Access Compliance Report

Public Rights-of-Way

(Curb Ramps)

Intersection ID: 27163	Main Street: HEATHERTON_PL	Cross Street: PROVIDENCE_ARBOURS_DR	Location: SW
ADA ID: 7A2C45188A3C	Ramp Type: Perp	Initial Pass/Fail: Fail	Overall Compliance: No
Codes/Mitigation Info/Possible Solution		Field Measurements/Component Compliance	
Severity Score: 13.75

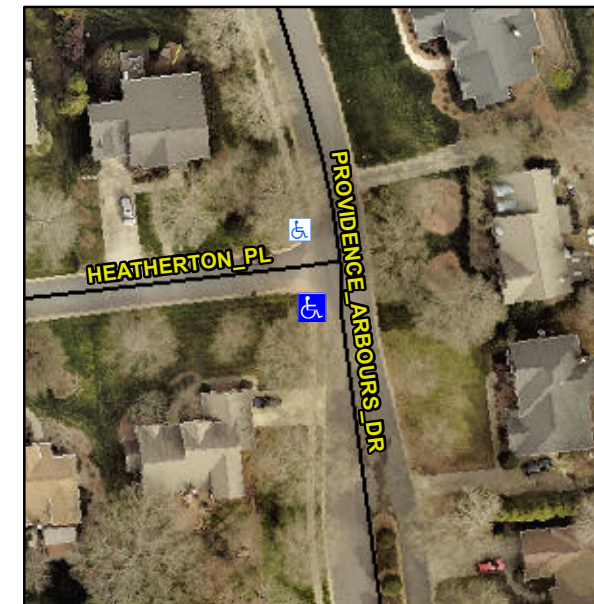
Not Found, R304.2.2, R304.5.3

Compliance	Description	Data	Compliance	Description	Data
N/A	Ramp Length (in)	36.0	No	Ramp Slope (%)	8.6
Yes	Ramp Width (in)	82.0	No	Ramp XSlope (%)	5.0
N/A	Flare Type LT	N/A	N/A	Flare Type RT	N/A
N/A	Flare Slope LT (%)	N/A	N/A	Flare Slope RT (%)	N/A
N/A	Flare Traversable LT?	N/A	N/A	Flare Traversable RT?	N/A
N/A	Landing Length (in)	N/A	N/A	DWS Provided?	N/A
N/A	Landing Width (in)	N/A	N/A	DWS Contrast?	N/A
N/A	Landing Slope (%)	N/A	N/A	DWS Length (in)	N/A
N/A	Landing X Slope (%)	N/A	N/A	DWS Full Width?	N/A
N/A	Landing Curb? (Y/N)	N/A	N/A	DWS Offset (in)	N/A
N/A	Shared Landing?	N/A			
N/A	Gutter Ponding?	N/A	N/A	Gutter Slope (%)	N/A
N/A	Gutter Lip Ht (in)	N/A	N/A	Gutter X Slope (%)	N/A
N/A	Painted X Walk1?	No	N/A	Painted X Walk2?	N/A
	X Walk 1 Direction	To N		X Walk 2 Direction	N/A
N/A	X Walk 1 Width (in)	N/A	N/A	X Walk 2 Width (in)	N/A
	X Walk 1 Slope (%)	3.4		X Walk 2 Slope (%)	N/A
	X Walk 1 X Slope (%)	2.2		X Walk 2 X Slope (%)	N/A

Remove & Replace Entire Ramp.
